## Installation Restoration ProgramWork Plan 45th Space Wing Facilities

# DRAFT PILOT STUDY REPORT PERMEABLE REACTIVE TREATMENT (PeRT)

Cape Canaveral Pilot Testing of PeRT Wall

# Response to EPA COMMENTS ON PILOT STUDY REPORT PERMEABLE REACTIVE TREATMENT (PeRT) WALL PILOT STUDY CAPE CANAVERAL AIR STATION DRAFT FINAL, DATED JUNE 1999

#### **PLAN VIEW**

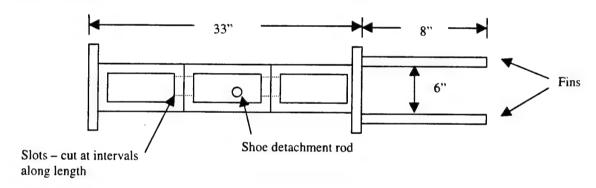
Dimensions on Plan View should be changed. The Mandrel was 48.0 feet and 11.2 feet. The JAG was 48.3 feet and 8.3 feet.

See response to first comment regarding lengths.

FIGURE 4-17
Potentiometric Surface Map
February 1998, Wells Screened 35 to 40 feet bis

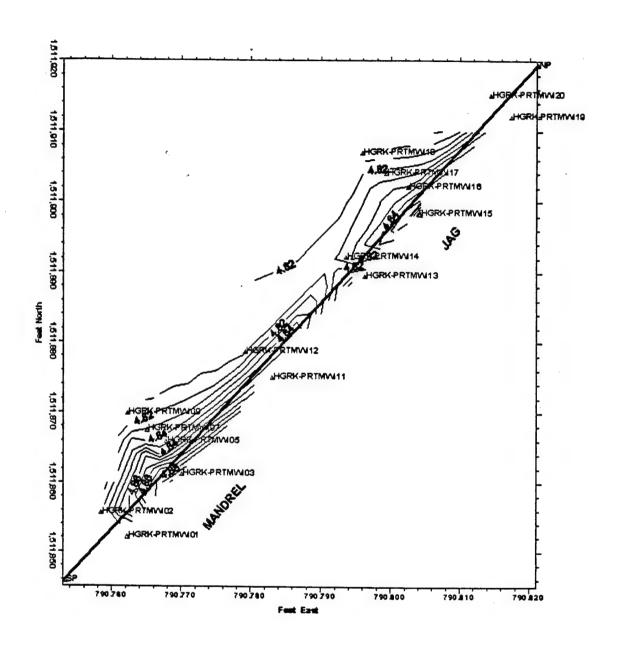
7		Table 4-34	COMMENT: C/E DCE should be C/T DCE. Please revise.
7			RESPONSE: Text will be modified as requested.
8		Figures 4-18, 4-19, and 4-20	COMMENT: The text labels associated with the monitoring wells and other objects is illegible. Please revise the figures to either increase the font size of the labels or reduce the scale of the map and adjust the labels accordingly.
8			<b>RESPONSE:</b> the three figures are being edited to show the wells used to construct the potentiometric surface, and refer to smaller scale maps for identification of the numerous wells around the PeRT wall. Reducing the scale of the map would render its purpose useless of showing the potentiometric surface for the whole area.
9	7-1	Section 7.1	<b>COMMENT:</b> Correct the reference to high OVA readings as per comment one.
9			RESPONSE: Text will be modified to list the maximum concentration as 450 ppm (as noted at HGRK-PRTMWD01).
